Modify date	Project: X-312 Rudder bearing spareparts		 JEFA MARINE A/S NIMBUSVEJ 2 2670 GREVE, DENMARK Tlf. +45-4615 5210 & Fax +45-4615 5208 E-mail info@jefa.com & WWW.jefa.com
Modify date			
Modify date	Scale 1:4	Date 2009-08-14	
Modify date	Material —	Drawing no. —	
Modify date	Filename (dwg) —		
Modify date	Drawn by J.F.	—

Modify date	Project: X-312 Update from plain bearings Rudder bearing spareparts	
Modify date		
Modify date	Scale 1:4	Date 2009-08-14
Modify date	Material —	Drawing no. —
Modify date	Filename (dwg) —	
Modify date	Drawn by J.F.	—

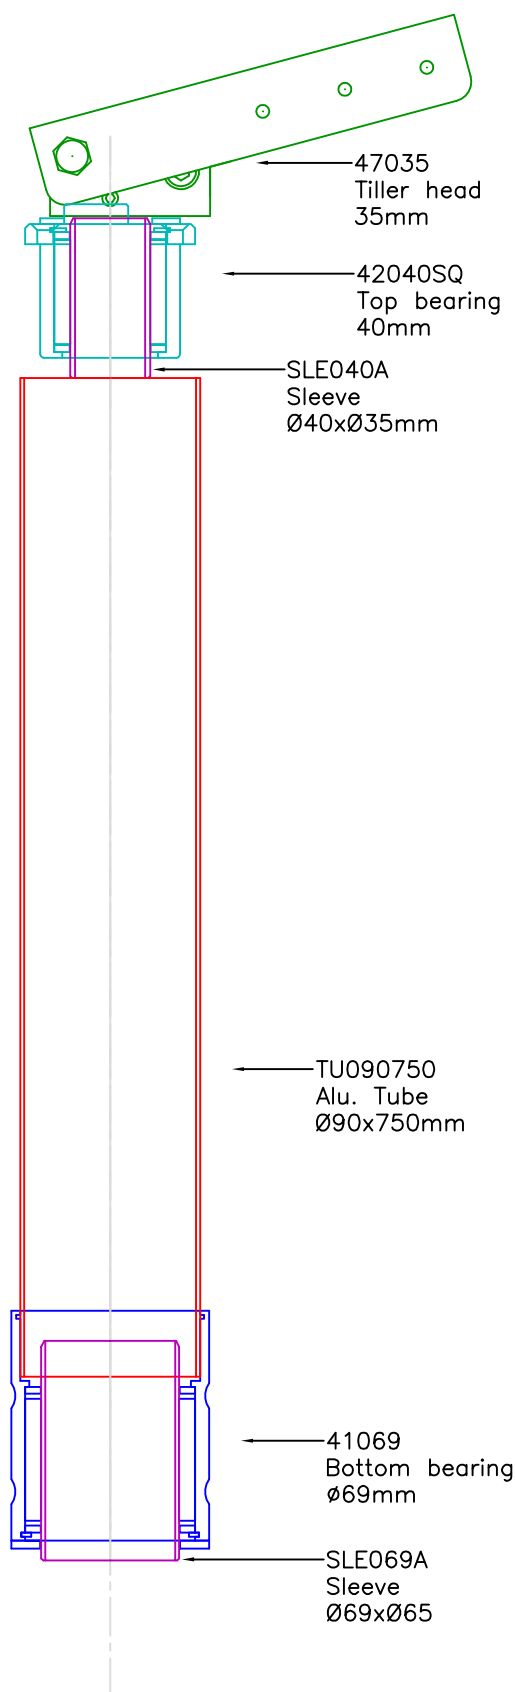
These parts shall be ordred, for an update:

item no	Spare part list:	Quantity
47035U	U-profil for 47035, Stainless 316	1
47035K	Alu. block Ø35, black anodised	1
M56-204	Washer Ø12xØ24x1mm, Plast	2
M56-210	Shaft Ø10x94mm, stainless	1
M07-107	Washer Ø40,5xØ79x4,5mm, Delrin	1
M03-191	Lock-ring Ø59,5xØ46x1,75mm, Delrin	1
M05-107	L-ring Ø40,5xØ55,5mm, Delrin	2
M01-201	Roller Ø8x44mm, Delrin	18
	Rollers M01-201 shall be used when the sleeve is the original dimension 39,92-40mm. Rollers M01-202 shall be used if the sleeve is worn down to 39,84-39,94mm	
ALTERNATIVE M01-202	Roller Ø8,05x44mm, Delrin	18
M07-143	Washer Ø69,5xØ99x4,5mm, Delrin	1
M03-207	Lock-ring Ø88,5xØ71x1,75mm, Delrin	1
M05-170	L-ring Ø69,5xØ84,5mm, Delrin	2
M01-301	Roller Ø8x57mm, Delrin	30
	Rollers M01-301 shall be used when the sleeve is the original dimension 68,92-69mm. Rollers M01-302 shall be used if the sleeve is worn down to 68,84-68,94mm	
ALTERNATIVE M01-302	Roller Ø8,05x57mm, Delrin	30
